Access Compliance Report Public Rights-of-Way (Curb Ramps)

Main Street: CALDWELL_LN Cross Street: MARKHAM_LN Location: SE

ADA ID: RPAT211103113703 Ramp Type: Type 4 - Parallel Initial Pass/Fail: Pass Overall Compliance: No Severity Score: 15

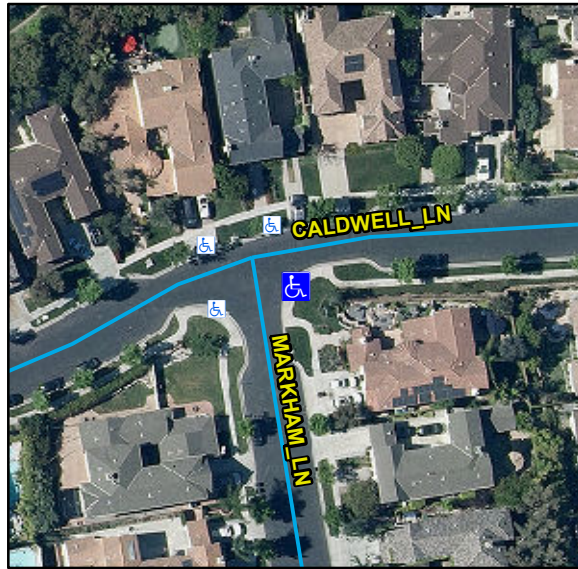
Crossing 1 Slope (%)	2.7		Crossing 2 Slope (%)	1.8
	Crossing 1 Cross Slope (%)	3.3		Crossing 2 Cross Slope (%)	2.5
Yes	Gutter Ponding	No	No	Curb Slope	14.8
Yes	Gutter Lip Height (in)	0		Road Run Slope (%)	0.3
No	Gutter Run Slope (%)	6.9		Road Cross Slope (%)	3.7
Yes	Gutter Cross Slope (%)	0.7	No	Perpendicular Joint Present	No
Yes	Overall Surface Condition	Acceptable			
	Cross Gutter Present?	No		Spandrel Present?	No
	Replace Cross Gutter?	N/A		Replace Spandrel?	N/A

Remove & Replace Curb Ramp With Two New Directional Ramps or Equivalent. Remove & Replace Gutter.

R304.2.2, R204.3, R305, R304.5.4, STD 1115
